PLANNING AND ZONING COMMISSION AGENDA

STAFF REPORT
KETCHUM PLANNING AND ZONING COMMISSION
REGULAR MEETING OF FEBRUARY 27, 2017

- PROJECT:** Argyros Performing Arts Center zoning code text amendment request to amend Title 17, Zoning Regulations, Chapter 17.125, Off Street Parking and Loading

STAFF REPORT
KETCHUM PLANNING AND ZONING COMMISSION
REGULAR MEETING OF February 27, 2017

PROPOSED EAST ELEVATION

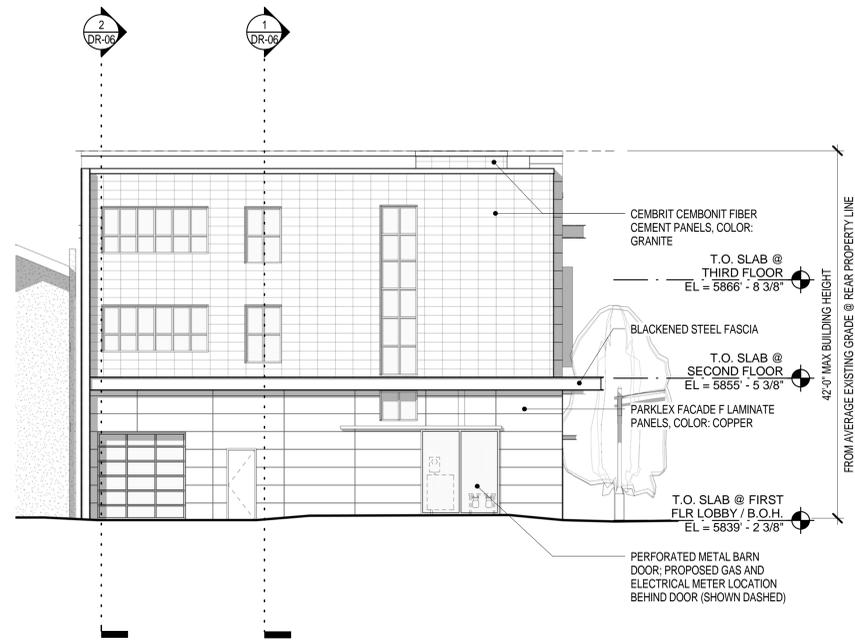
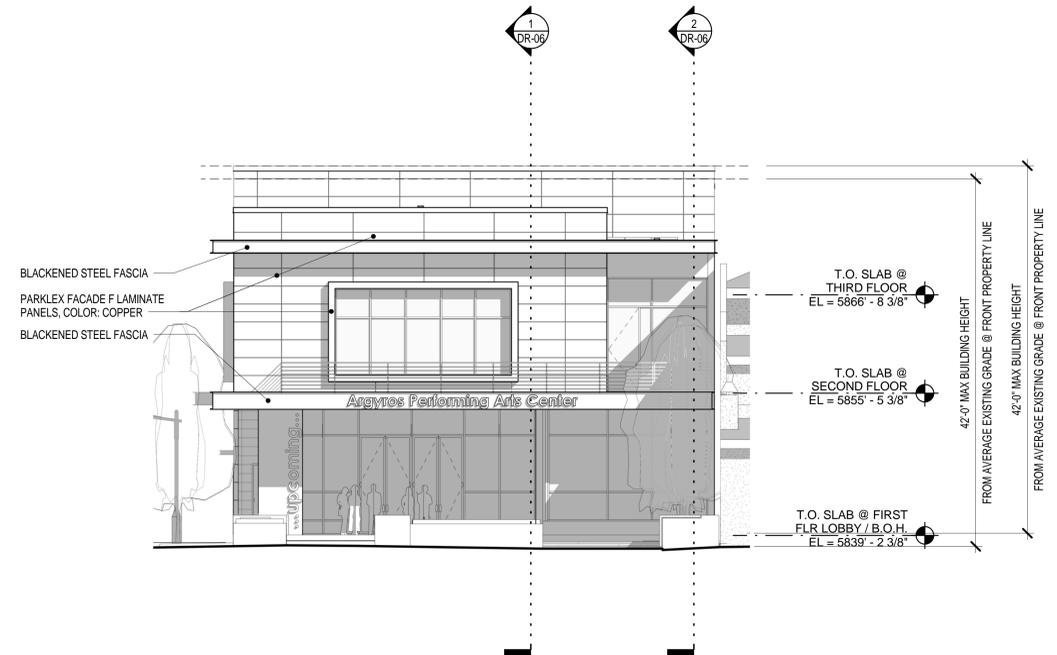
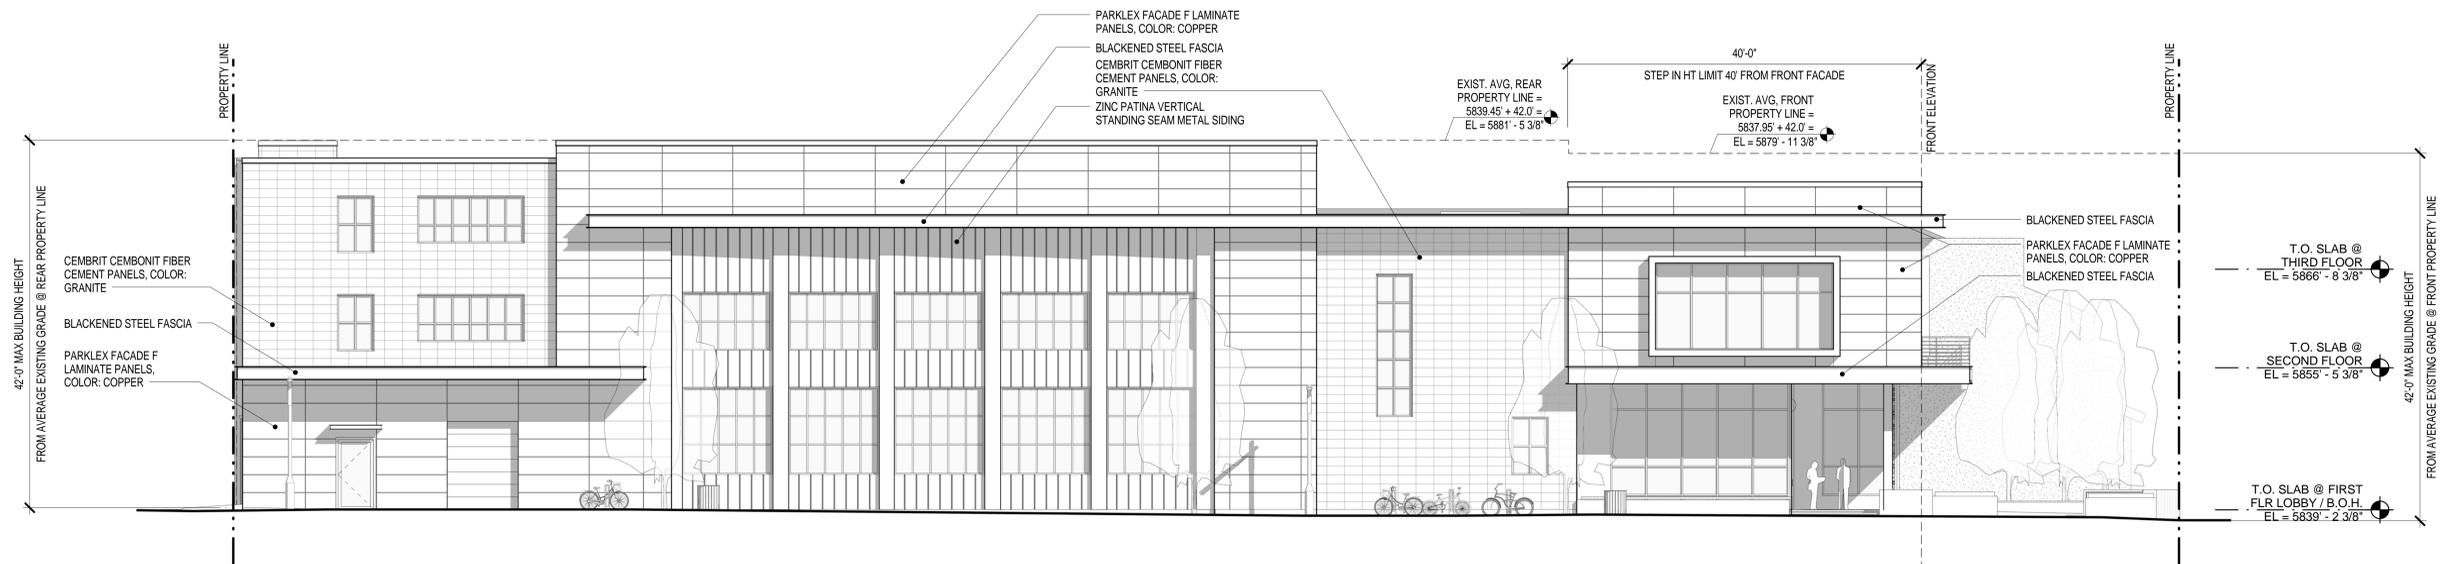
<i>of the building. The variation in materials, windows and cantilevered segments serve to break up the vertical and horizontal massing of the building.</i>
<input checked="" type="checkbox"/>	<input type="checkbox"/>	<input type="checkbox"/>	17.96.060(F)(3)	There shall be continuity of materials, colors and signing within the project.
			<i>Staff Comments</i>	<i>Staff finds that the applicant has maintained a continuity of materials and colors that both serve to complement one another, and provide definition to the building. Staff finds that the materials serve to provide depth to the principal building, as well as to further break up the appearance of bulk and flatness, in combination with the architectural design of the proposed building.</i> <i>The applicant states that selection and composition of building materials has been selected with the designed intention to bring warmth through the use of wood laminate panels, and the form will create human-scaled texture as well. The high-pressure decorative exterior grade compact wood laminate panels are proposed along the black box volume, the perimeter or the theater volume, and along the ground floor of the east back-of-house area. The proposed inclusion of the vertical zinc siding is intended to act as a secondary material to the theater volume. The standing zinc is located on a series of pleats that canted towards Main Street at twelve-feet (12') from center. The applicant has utilized "pleats" with the intent to created undulation along the Main Street facing façade. The applicant states that the volume containing the north egress stair, as well as the 2nd and 3rd floor back-of-house facades will be a light grey fiber cement wall panels, intended to complement the selected material palette. The applicant proposes to utilize a blackened steel brow at the level of the second floor framing, which covers the plaza area below. A second upper steel brow is set four-feet (4') and eight-feet (8') beneath the top of the parapets of both the black box and theater volumes. The intent the steel brow is to unify the structure, and to minimize the perception of building height. The applicant is also proposing to utilize signage and other accents, which will match the blackened finish of the steel brows.</i>

<i>Staff Comments</i>	<i>The proposed elevation views provided by the applicant demonstrate that the building walls provide variation, including undulations on all street-facing facades. The applicant has used pleats along the principal building, which are set in from the adjacent compact wood laminate siding, to provide shadow and depth to the façade. Changes in material and roof curb height are also used to break up the building bulk.</i>
<input checked="" type="checkbox"/>	<input type="checkbox"/>	<input type="checkbox"/>	17.96.060(F)(6)	Building(s) shall orient towards their primary street frontage.
			<i>Staff Comments</i>	<i>The front entrance of the building orients towards Main Street. The plaza area is located on the corner of Main Street and First Street East, and the entrance is setback from the street, located underneath the cantilevered black box. The plaza provides ample gathering space that brings attention to the front entrance of the building.</i>
